Client
Riverside Developments

Address
Norfolk House
High Street
Shoreham on Sea
BN43 5EN

Title
Proposed Rear and Side Elevations
Change of Use Conversion and Extension

drawing number
C-262-12

PROPOSED REAR (SOUTH) ELEVATION

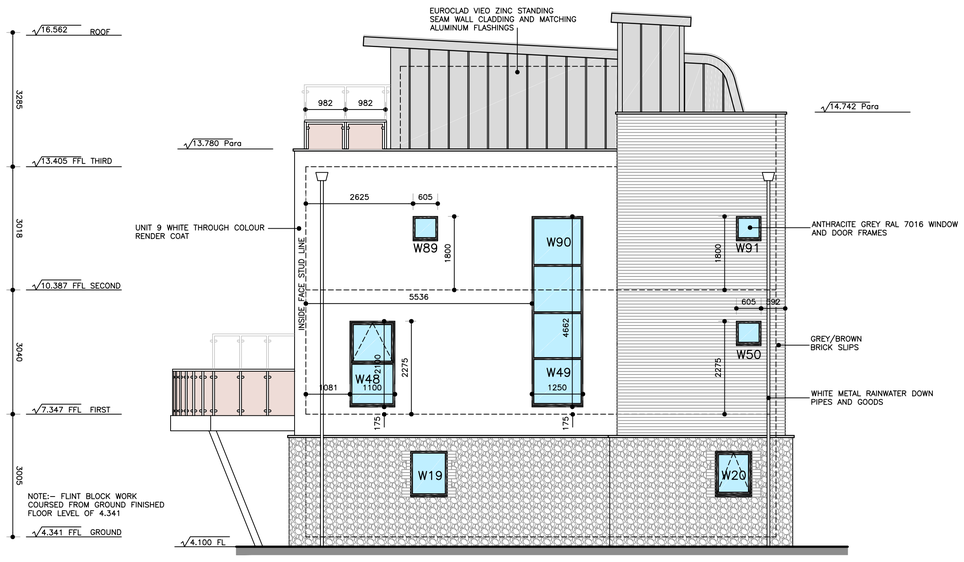
Schedule Minor Amendments
Rear (South) Elevation
Compared to Approved Drawing GHS–147–200 Rev D

1).. Grey/Brown Brick Slips
2).. Windows Colour Anthracite Grey RAL 7016
3).. Final Render Colours
4).. Door to utility room replaced with window
5).. Composite/solid timber light grey doors added for rear access from garages.
6).. Matching Grey/Brown brick work quoins to window/door openings on ground floor with flint block work.
7).. Structural balustrade glazing to first floor balconies to match other balustrades.
8).. Patio style sliding doorsets to third floor roof terraces and first floor balconies in lieu of sliding/folding.
9).. Eurocad standing seam Zinc Vieo cladding added to third floor inset walls in lieu of render.
